**STAFF REPORT
SPECIAL CERTIFICATE OF APPROPRIATENESS
FOR THE PROPERTY AT
415 ARAGON AVENUE
A LOCAL HISTORIC LANDMARK**

Proposal: The application requests design approval to correct work without a permit with additions and alterations to the residence and detached garage, and sitework.

Architect: A. R. Poza Architect, Inc. (Albert Poza)

East - Sheet A.6

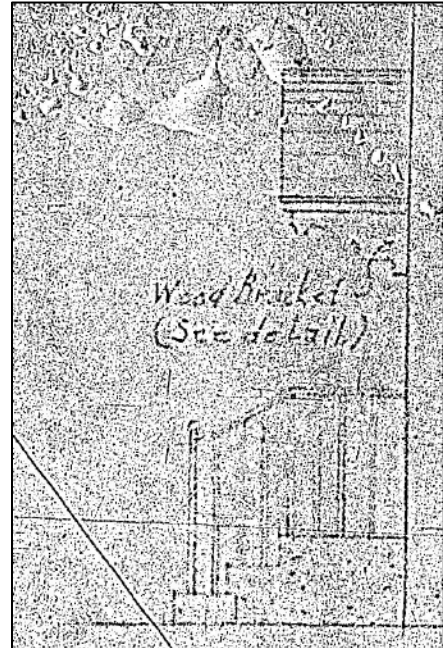
At the south end of the existing residence, the proposed copper-clad door hood is visible at the front door. It is noted to project 3’-0” from the south façade. Note that, as drawn, it does not match the original design intent (see Figures 6). The carport with two arched openings obscures a portion of the existing residence. To the north is the flat-roofed master bedroom addition. The addition façade is largely blank except for a pair of casement windows (no protruding sill, typical on the additions). Beyond, the detached garage is visible with the roofed connection to the back terrace of the residence. At the garage – to be converted to living space – a window is proposed to be relocated and a door opening removed.

12. Provide details of all repair/restoration work to be done on the original features of the residence.
13. Provide construction details and sections of the front door hood. Work with Staff to ensure it is a replication. If this cannot be achieved, the element should be eliminated rather than adding a conjectural feature.

Figure 9: First BOA submittal with flat roofed carport

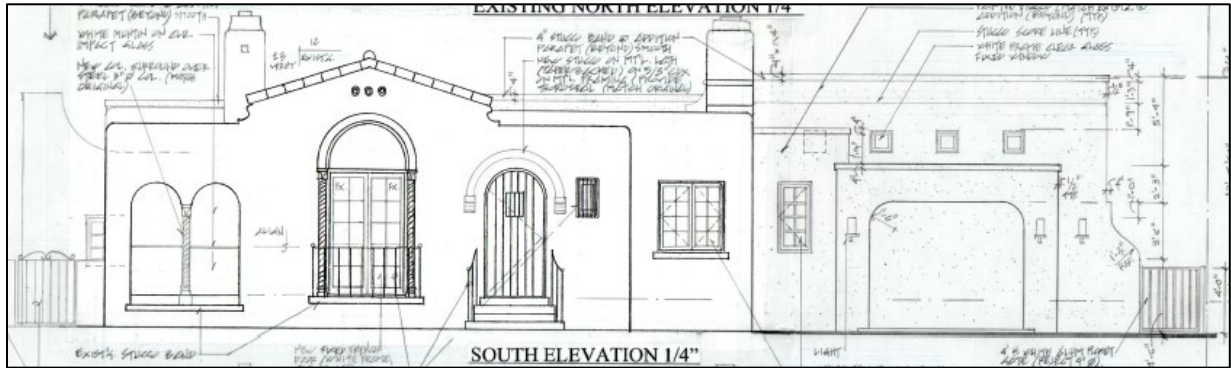
Similarly, the carport seems repetitive of the gable roof portion on the existing home. The arched opening competes with distinctive series of arches on the original home arches and perhaps should not be replicated at the carport. However, the original proposal included a flat roofed carport but was not accepted by the BOA (see Figure 9). Staff suggests that the carport be open on three sides and not engaged with the master bedroom suite.

1. Work with Staff on the relocation of the carport connector and the restudy of the carport details.
2. The front porch is to remain open/unenclosed. The concrete added atop the porch floor is to be removed (original sills to remain) and an iron railing to replicate the original is to be returned to the openings.
